M-2021-009; Third Adequacy Response

RE: Young Ranch Resource Quarry (M-2021-009), Third Adequacy Response

On behalf of the Young Ranch Resource, LLC, please allow this letter to serve as response to your April 14, 2022 dated Adequacy Review No. 3 for the Young Ranch Resource quarry, Colorado Division of Reclamation, Mining and Safety (CDRMS) File No. M-2021-009.

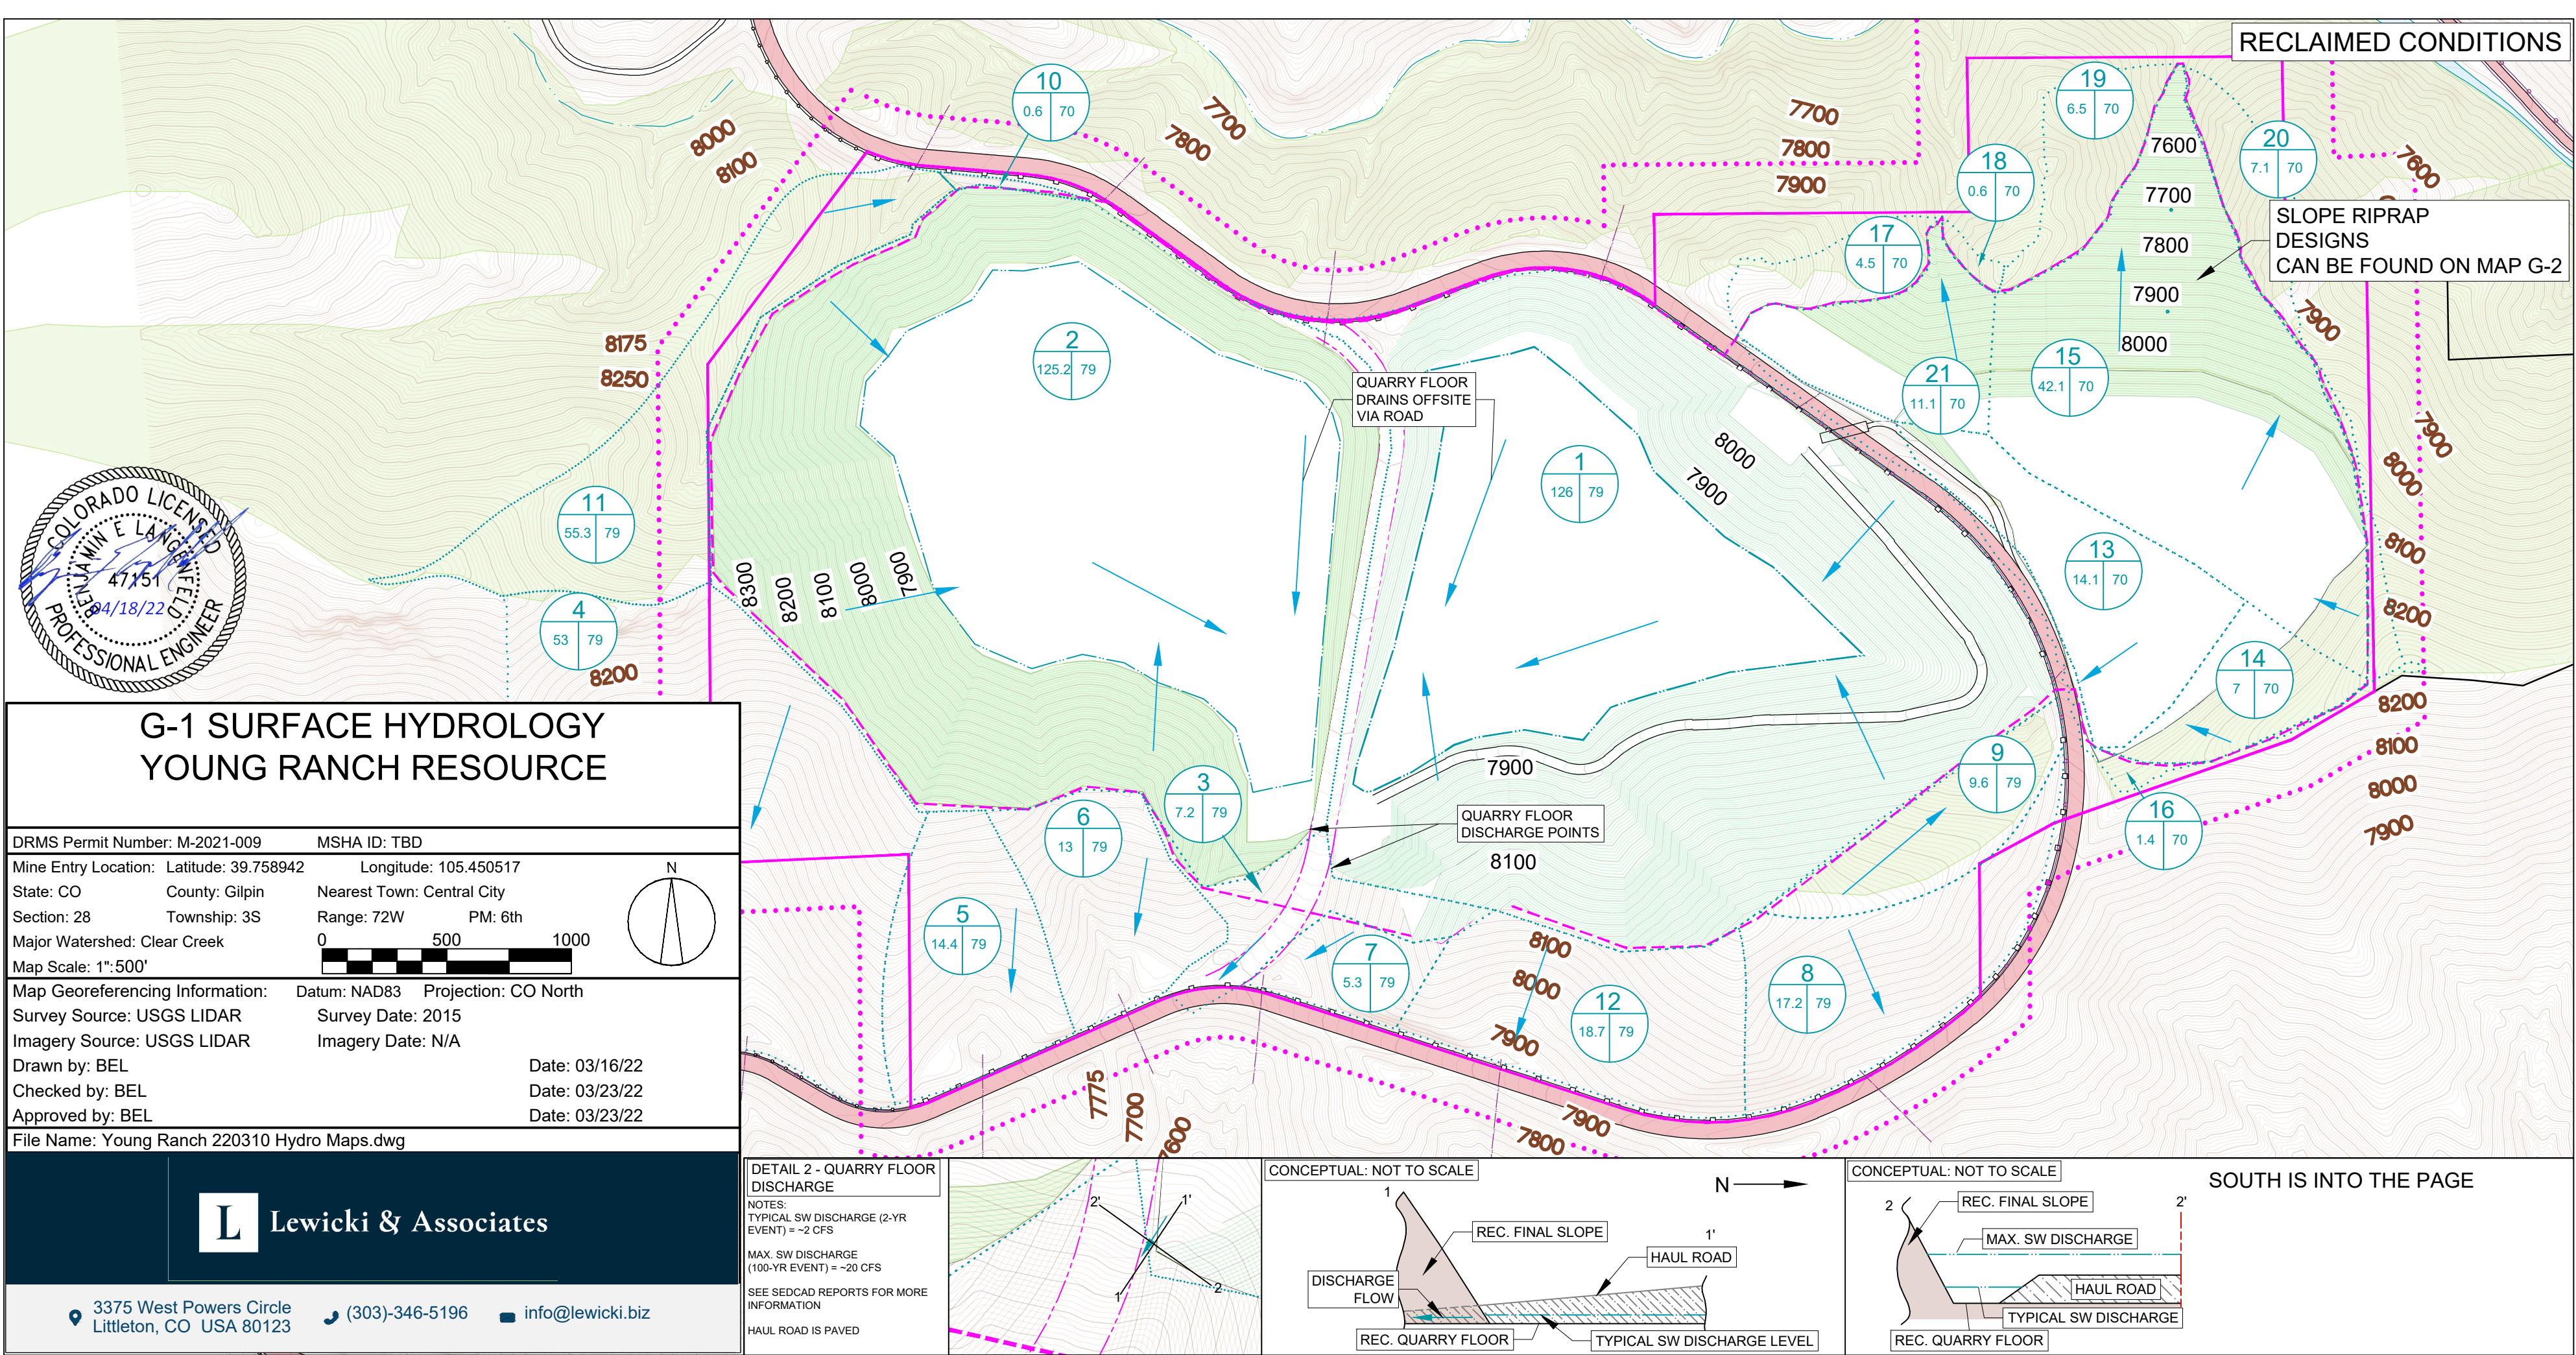
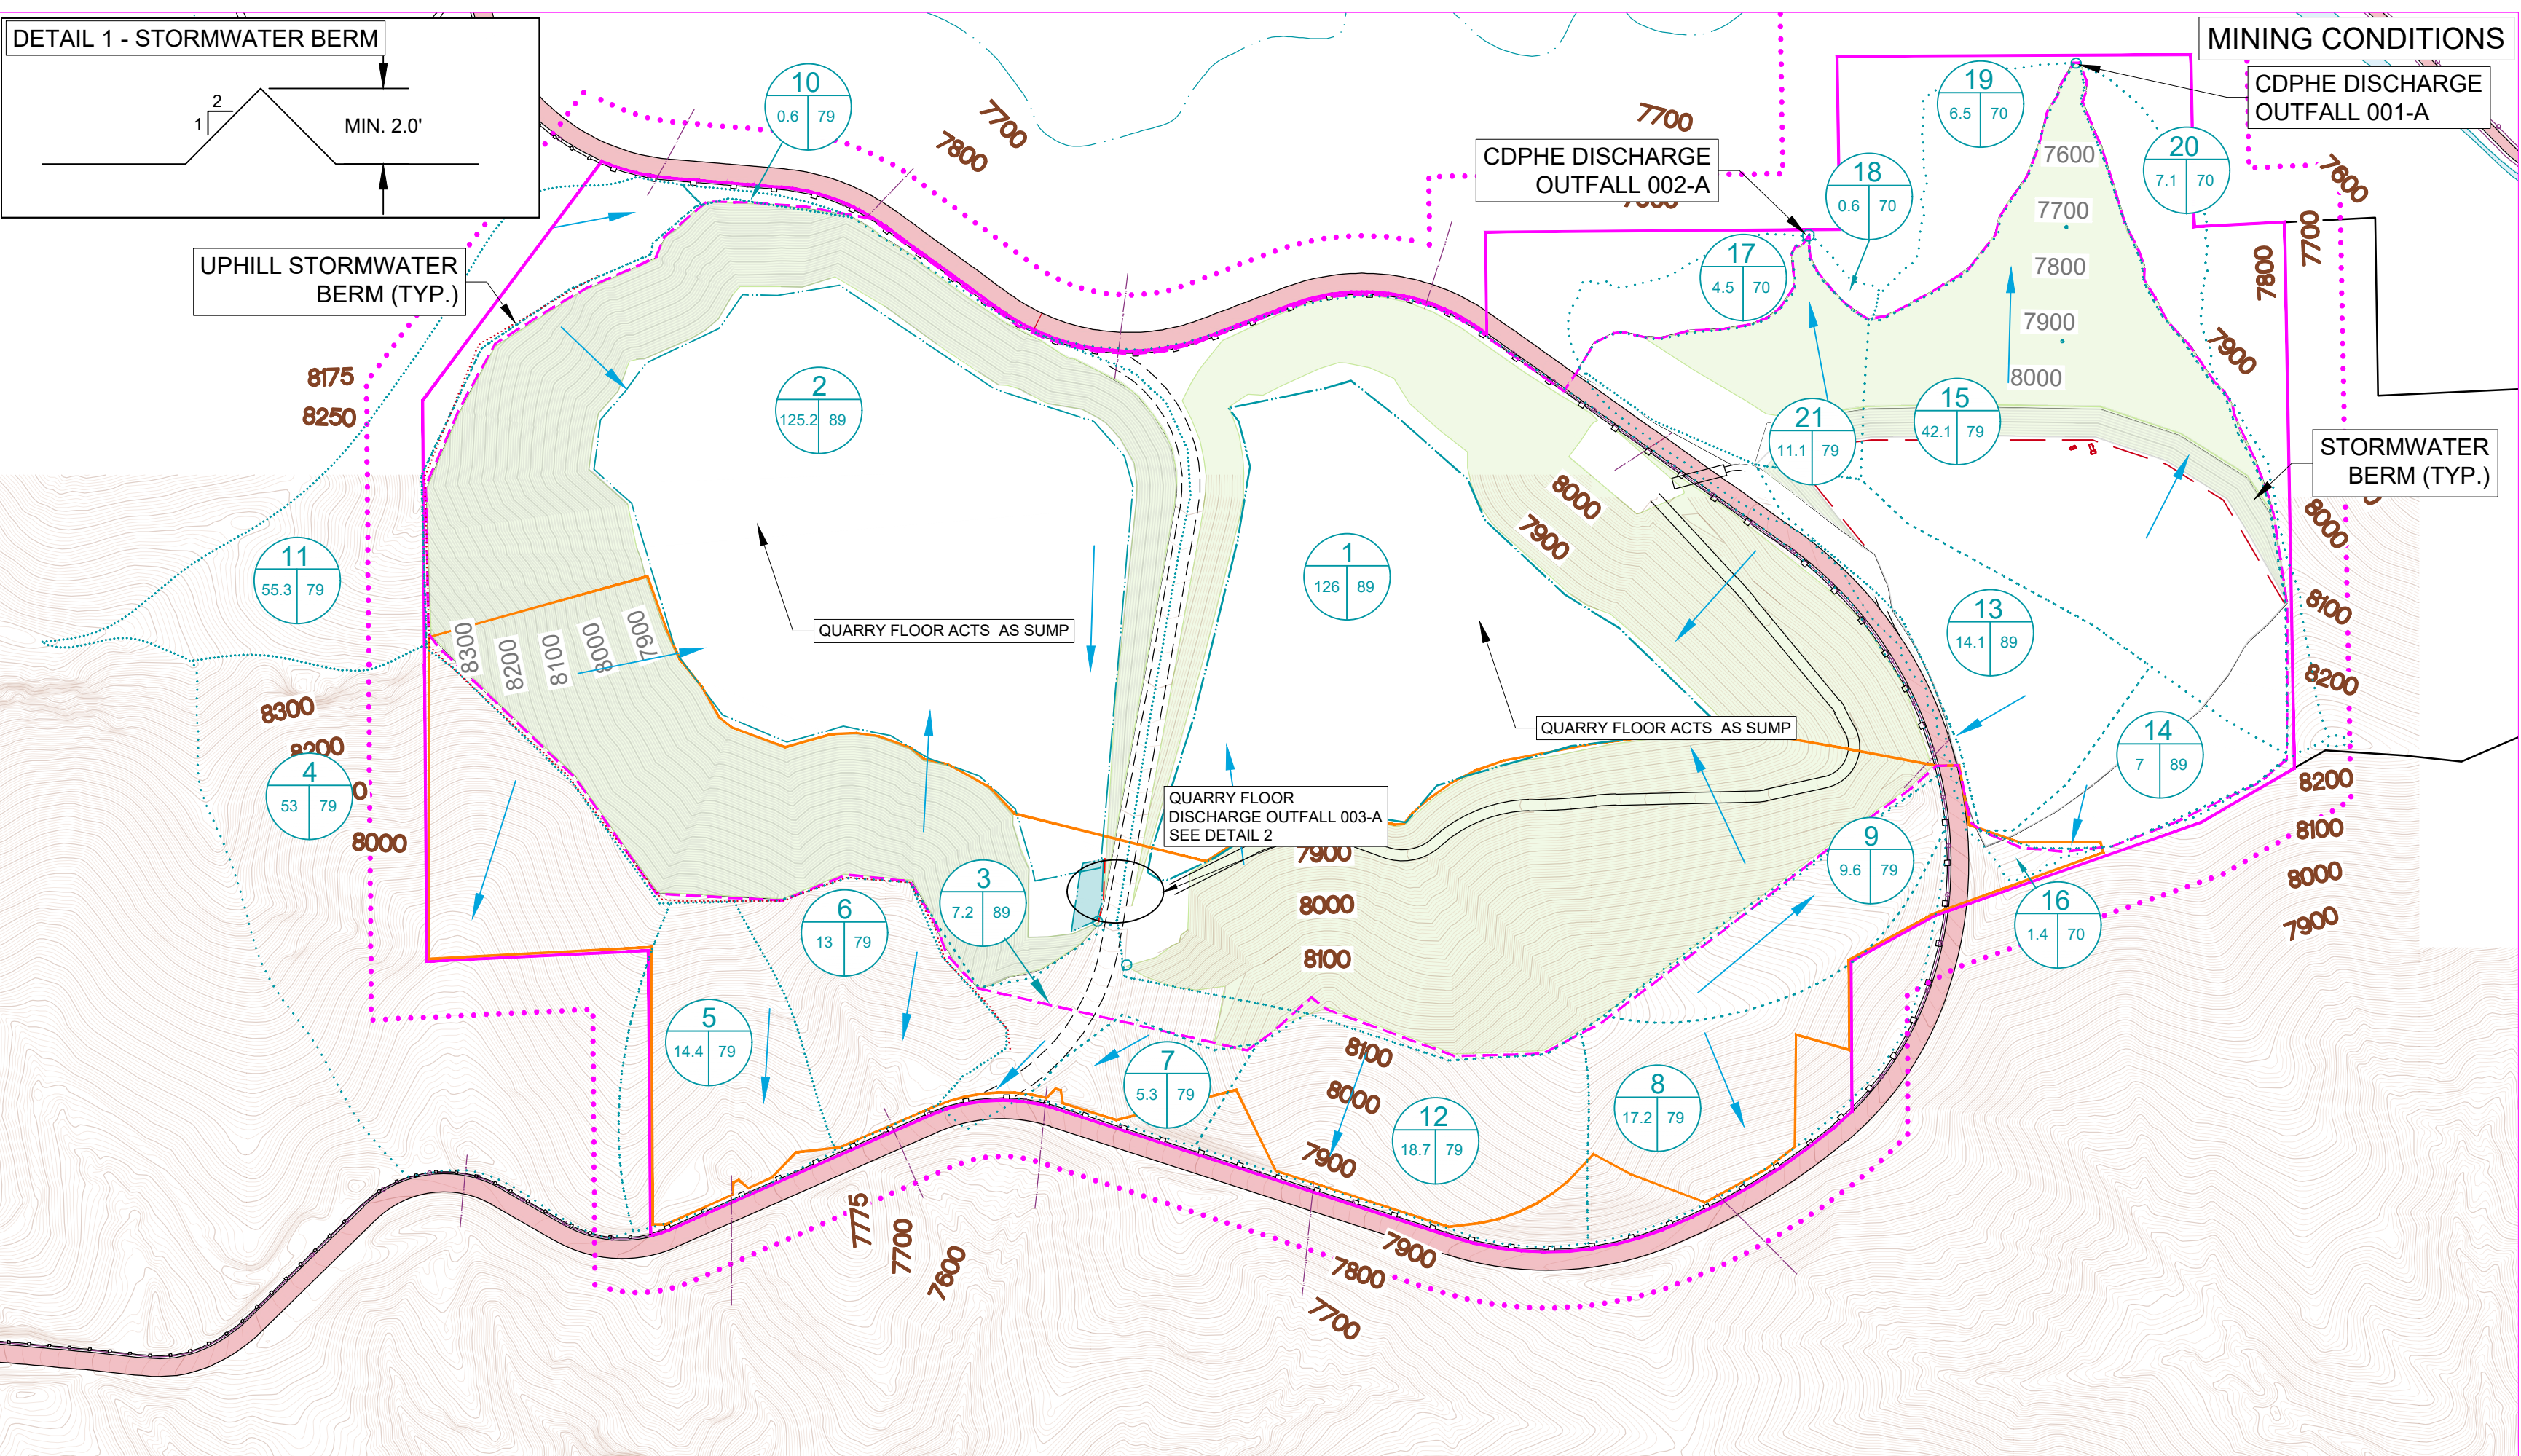
- c. Item 12. Regarding discrepancies between the Mining Runoff tables and the maps, there are still apparent errors. For example, the curve numbers on Map G-1 (CN = 89) do not match the tables for basins 1 and 2 (CN = 79), for the reclaimed condition. Please explain this, or revise the map or tables, and check all of the values.*

Map G-1 has been corrected to show the curve numbers that match the runoff tables.
